EPA REGION 8'S RESPONSE TO PETITION FOR REVIEW

# **Response to Public Comments**

# Class III Area Permit No. SD31231-00000, Aquifer Exemption Decision And Class V Area Permit No. SD52173-00000

Powertech (USA) Inc. P.O. Box 448 Edgemont, South Dakota 57735

Figure A. Gott et al., 1974, Plate 2 showing the extent of the Dewey Fault and Structural Zone with the Dewey-Burdock Project Area superimposed.

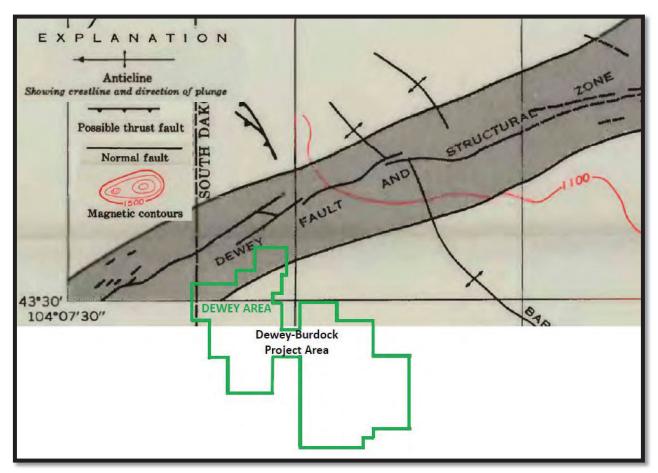
A commenter referred to Plate 4 from Gott at al., 1974, as the Gott fault map. Powertech used Plate 4 as a base map for Plate 6.24 of the Class III Permit Application and superimposed the Dewey-Burdock Project Boundary to show where the collapse features and breccia pipes identified in Gott et al., 1974, are located relative to the Project Site. Plate 6.24 shows that none of these features are located inside the Project Area. Figure B is an excerpt from Plate 6.24. The features shown inside the project boundary are Beaver Creek and paleostreams. The linear feature in the red box inside the Dewey-Burdock Project Area is the southeast boundary of the Dewey-Fault and Structural Zone shown in Plate 2.

There is no evidence of the Dewey fault inside the project area. (Brobst, 1961, *Geology of the Dewey Quadrangle Wyoming-South Dakota*, USGS Bulletin 1063-B.) Brobst, 1961, describes the Dewey Fault in the Dewey quadrangle geologic report as the fault passing through the town of Dewey and refers to the fault located to the southeast without a name. Braddock, 1963, does not refer to more than one fault plane related to the Dewey Fault in the Geology of the Jewel Cave SW quadrangle report (Braddock, W.A., 1963, *Geology of the Jewel Cave SW quadrangle Custer County, South Dakota*, USGS Bull 1063-G). Gott, et al., 1974, includes both faults described by Brobst, 1961, in the Dewey Fault and Structural Zone. The boundaries of this structural zone are shown in Plates 2 and 4 of the Gott et al., 1974 report. The extent of the Dewey Fault and Structural Zone as defined by Gott in Plate 2 near the Dewey-Burdock Project Site is shown in Figure A. The Dewey-Burdock Project Site Boundary is superimposed on Plate 2. Although Gott shows the Dewey Fault and Structural Zone as extending into the northwestern edge of the Dewey-Burdock Project Site, there is no evidence of any fault inside the Project Area.

Figure E. Areas of the Inyan Kara Group aquifers approved by this Record of Decision.

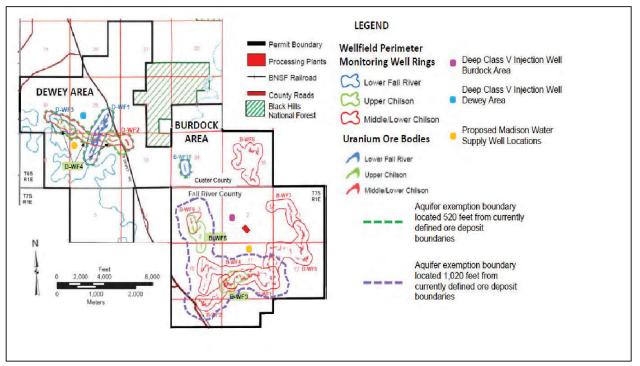
Powertech requested an expanded AE area to accommodate additional ore resources identified after the Class III Permit Application was submitted. EPA reviewed the Preliminary Economic Assessment reports developed by consultants documenting independent audits of mineral resource estimates at the Dewey-Burdock Project Site and determined that the commercially producible ore resource boundary had expanded in Burdock Wellfields 1 through 5, 9 and 10 since Powertech submitted the Class III Permit Application, justifying expanding the AE boundary for these wellfields. However, the commercially producible ore resource boundaries had not expanded for the other wellfields, so EPA did not expand the AE boundaries for these other wellfields. Because Powertech needs to do additional work to demonstrate that the potentiometric surfaces in Burdock Wellfields 6, 7 and 8 are able to sustain adequate monitoring of ISR operations in the overlying Upper Chilson aquifer, EPA is postponing approval the aquifer exemption in the area of Burdock Wellfields 6, 7 and 8 until Powertech performs further aquifer testing in that area.

original AE boundary proposed by Powertech in the Class III Permit Application. The blue dashed line is the expanded AE area Powertech requested after the first draft Class III Area Permit was issued.

Figure 3.2-6: Overall Process Flow Diagram

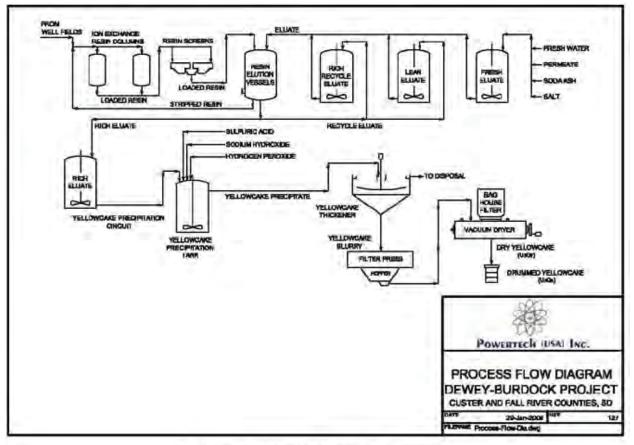
361. Powertech raises a comment regarding the statement in the CEA that Powertech proposes to store, use, and receive shipments of anhydrous ammonia (NH3). According to Powertech, it does not propose to use ammonia at the Dewey-Burdock Project. Powertech refers to Figure 3.2-6 in the approved NRC license application and explains that it shows that sodium hydroxide will be used in the precipitation circuit instead. Powertech also refers to Table 3.2-1 in the approved NRC license application, which lists the process-related chemicals and quantities planned for the project, likewise does not include ammonia. Powertech requests removing mention of anhydrous ammonia from this paragraph.

EPA agrees with Powertech's comment and has updated the two references to "anhydrous ammonia" (NH3) in the CEA Section 12.2, and instead replaced them with sodium hydroxide. We have included Figure 3.2-6 in the approved license application here.
